**MONTGOMERY COUNTY HISTORIC PRESERVATION COMMISSION**  
**STAFF REPORT**

<b>Address:</b>	8017 Hampden Lane., Bethesda	<b>Meeting Date:</b>	3/25/2020
<b>Resource:</b>	Contributing Resource <b>Greenwich Forest Historic District</b>	<b>Report Date:</b>	3/18/2020
<b>Applicant:</b>	Mark and Marjorie Kramer Mark Kramer, Architect	<b>Public Notice:</b>	3/11/2020
<b>Review:</b>	HAWP	<b>Tax Credit:</b>	n/a
<b>Case Number:</b>	35/165-20B	<b>Staff:</b>	Dan Bruechert
<b>PROPOSAL:</b>	Entrance Removal, Rear Addition, Tree Removal

1 PROPOSED REAR ELEVATION  
SCALE: 1/4"=1'-0"

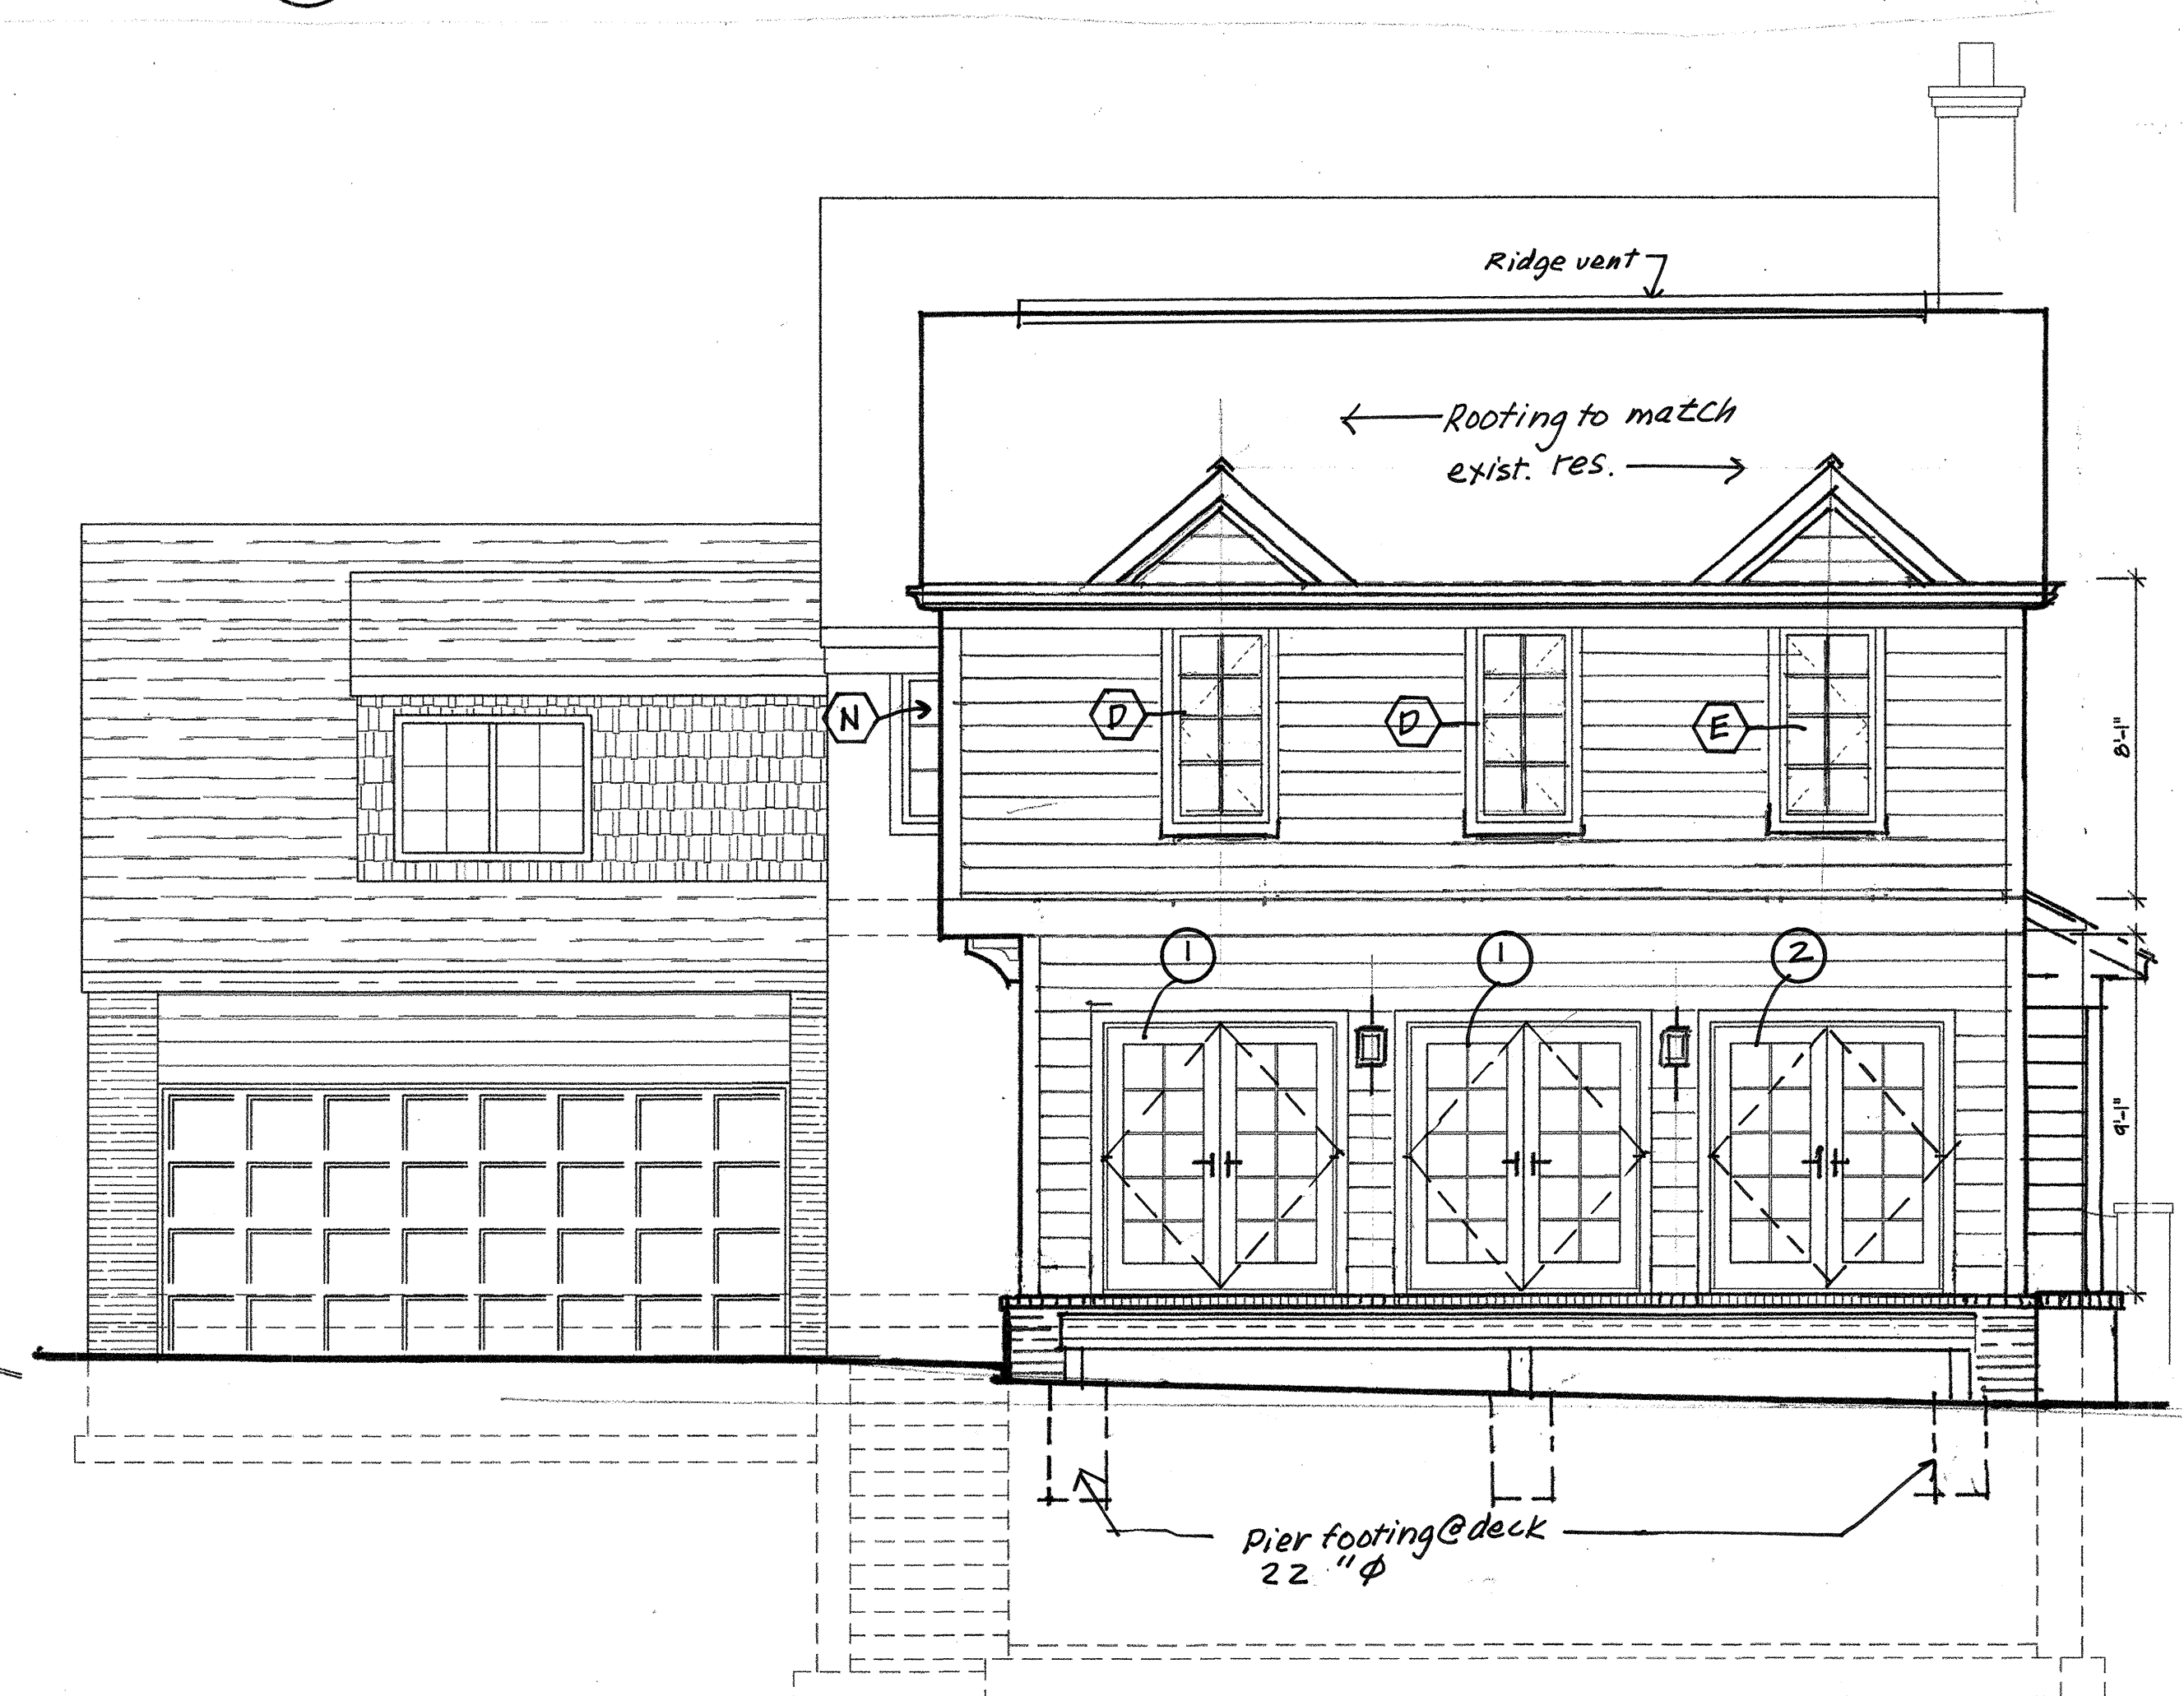
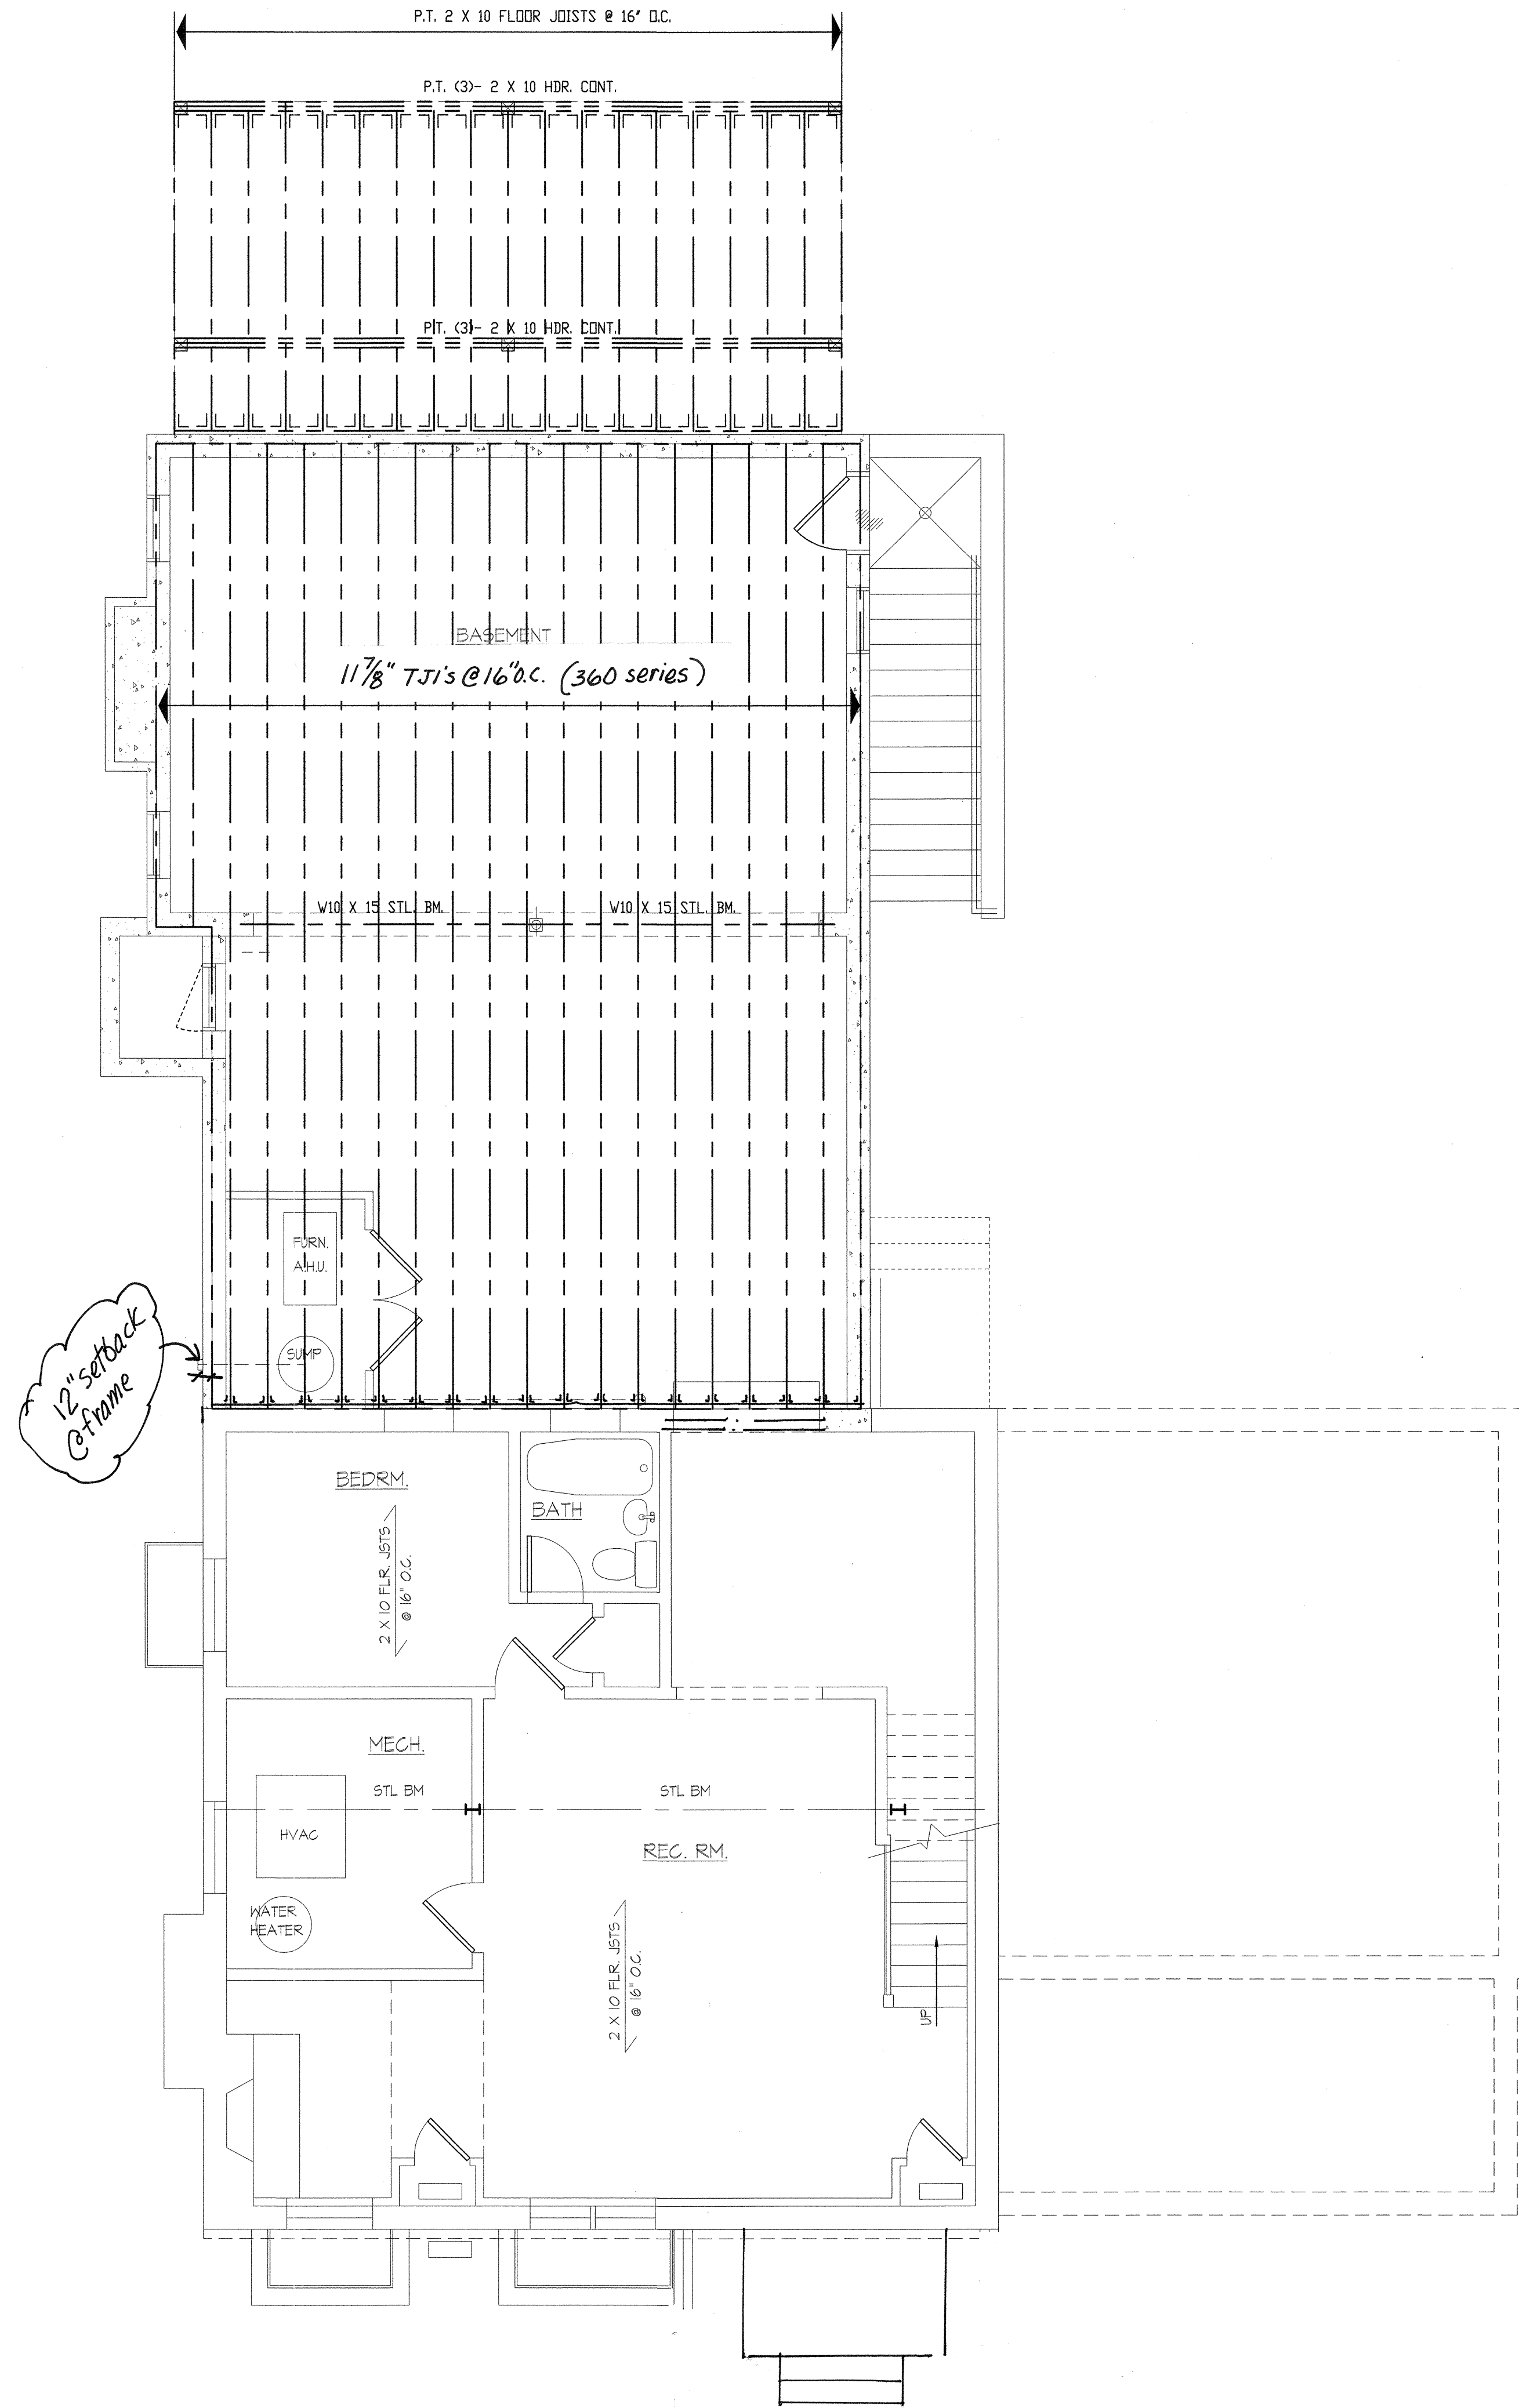
In place of the existing one-story addition, the applicant proposes installing a new two-story rear addition with a full basement. The siding of the proposed addition will match the siding found on the second floor of the historic house. The asphalt shingle roofing will match the roofing installed on the historic house. The rear deck will be wood, and because it is so close to grade a railing is not required.

The Greenwich Forest *Design Guidelines* offer significant flexibility when it comes to additions to contributing and non-contributing resources. Additions to contributing resources must “preserve as a recognizable entity the outline of the original house...” and the house must be a matching style, and the addition’s ridgeline must be lower than the historic principle ridgeline. The *Guidelines* also place a maximum lot coverage of 25%. Staff finds that the proposed addition is the same style as the historic house, as required and that the roof ridgelines are lower than the historic side gable, as required.

The proposed addition has only been slightly modified from the proposal presented at the preliminary consultation. The addition will be clad in siding to match the 2<sup>nd</sup>-floor of the historic house. The windows will be aluminum-clad wood Pella windows and doors, and the roof will be covered in architectural shingles that match the existing roofing. Staff finds that the materials are compatible with the historic house. Staff additionally finds that the addition is designed to match the Tudor Revival style of the historic house, as required by the *Design Guidelines*.

A general requirement of additions to historic houses is that the addition remains within the wall plane of the historic massing. That is not the case in Greenwich Forest and side additions and (side projecting additions) are allowed provided the setback between the two houses is at least 18’ (eighteen feet). At the Preliminary Consultation hearing, the majority of the HPC indicated that the side projection was acceptable under the *Design Guidelines* and that the change would not have a significant impact on the surrounding district because the projection is more than 60’ (sixty feet) from the right-of-way.

The applicant made two changes to the design based on the feedback of the HPC. First, the north wall of the addition is inset 1’ (one foot) from the north wall of the historic house, expressing the historic footprint, as required by the *Design Guidelines*. The applicant further reduced the rear gable by an additional 6” (six inches). The rear gable roof is now 3’ (three feet) lower than the principal, historic side gable. Staff finds that these changes are positive alterations and bring the house into compliance with the *Design Guidelines*.

REVISED FRONT ENTRY PORCH ELEMENT

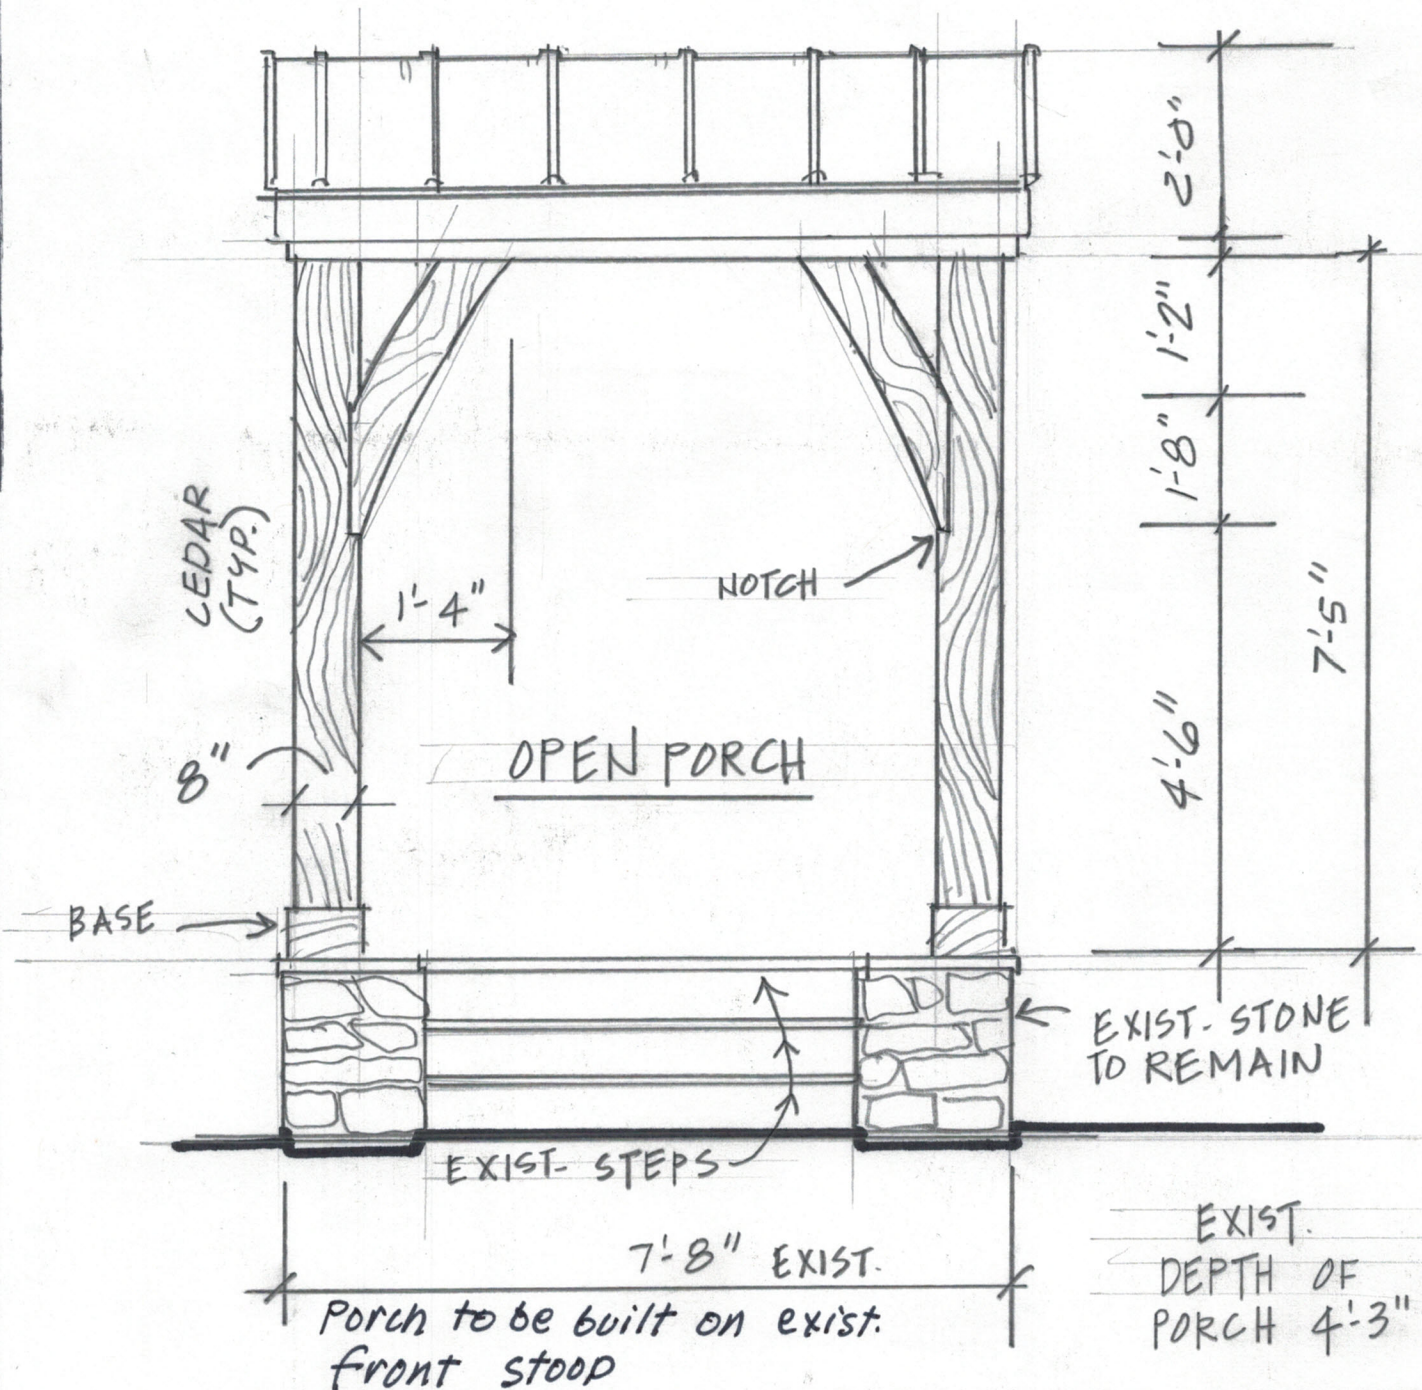
1. Proposed Porch to be built on top of exist. stoop & not enlarged.
2. Column details to match exist column details @ front
3. Roof to be LOWER with less slope
